# HISTORIC AND DESIGN REVIEW COMMISSION

**HDRC CASE NO:** 2023-294  
**ADDRESS:** 314 FLORIDA ST  
**LEGAL DESCRIPTION:** NCB 3010 BLK 8 LOT 4  
**ZONING:** R-6, H  
**CITY COUNCIL DIST.:** 1  
**DISTRICT:** Lavaca Historic District  
**APPLICANT:** Jason Moran/Jason Moran Collaborative Ventures LLC  
**OWNER:** Joe Salinas/SALINAS JOSE PEDRO &  
**TYPE OF WORK:** Construction of a detached, rear accessory structure  
**APPLICATION RECEIVED:** July 07, 2023; Complete on August 14, 2023  
**60-DAY REVIEW:** October 13, 2023  
**CASE MANAGER:** Edward Hall

The applicant is requesting a Certificate of Appropriateness for approval to construct a rear, detached accessory structure at 314 Florida Street, located within the Lavaca Historic District. The proposed new construction will feature a footprint of approximately 900 square feet.

**7 ROOF PLAN**  
1/4" = 1'-0"

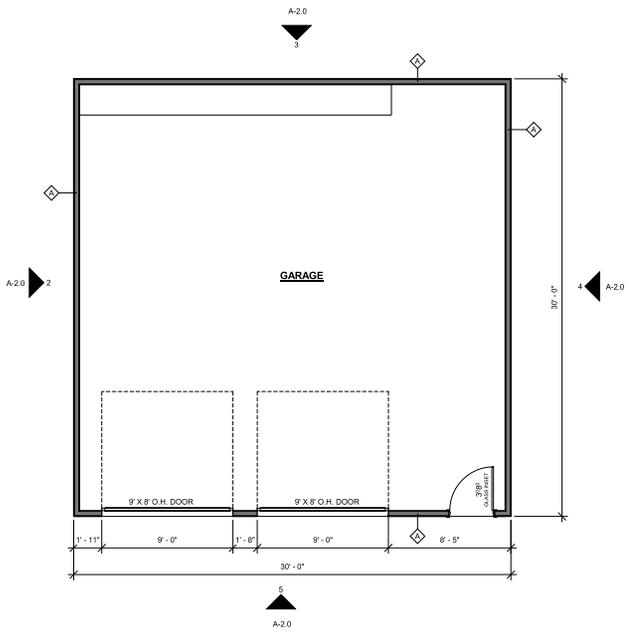
- e. **MATERIALS** – The applicant has proposed materials that include wood siding to match that of the historic structure (profile 117) and a metal roof. Staff finds the proposed siding to be appropriate. Staff finds that metal roofing materials should either be standing seam or v-crimp, to match the roofing material of the primary historic structure. If a standing seam metal roof is used, it should feature smooth panels that are 18 to 21 inches in width, seams that are 1 to 2 inches in height, a crimped ridge seam and a standard galvalume finish. Ridge caps and panels that feature striations or corrugation should not be installed.

- i. That either v-crimp or standing seam metal roofing be installed, as noted in finding e. If a standing seam metal roof is used, it should feature smooth panels that are 18 to 21 inches in width, seams that are 1 to 2 inches in height, a crimped ridge seam and a standard galvalume finish. Ridge caps and panels that feature striations or corrugation should not be installed.
- ii. That the applicant meets all setback standards as required by city zoning requirements, and obtains a variance from the Board of Adjustment if applicable.

A standing seam metal roof inspection is to be schedule with OHP staff to ensure that roofing materials are consistent with approved design. An industrial ridge cap is not to be used.

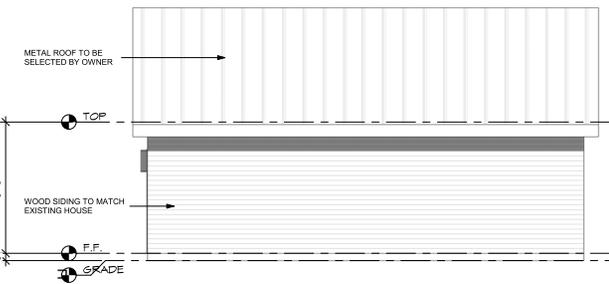
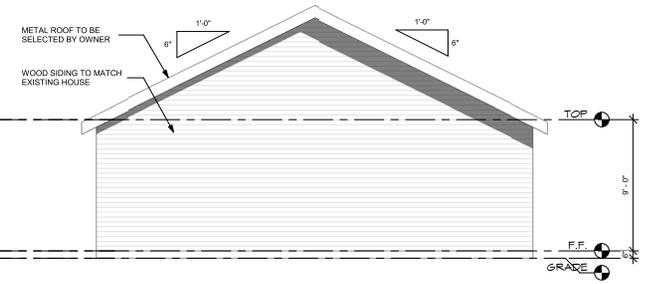
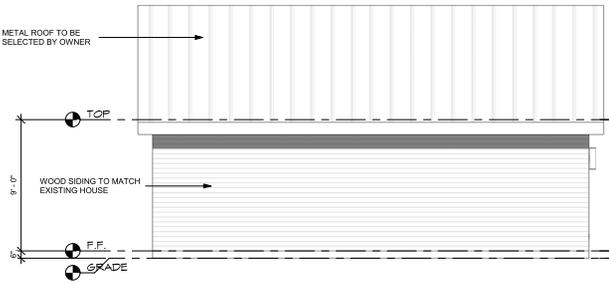
- f. **GARAGE DOORS** – The applicant has not specified garage door materials at this time. The applicant has proposed two separate garage doors with multiple-lite profiles. Generally, staff finds this to be appropriate; however, staff finds that the doors be wood or have the appearance of wood. Staff finds the installation of a vinyl door to be inappropriate. Additionally, high quality aluminum doors may be appropriate.
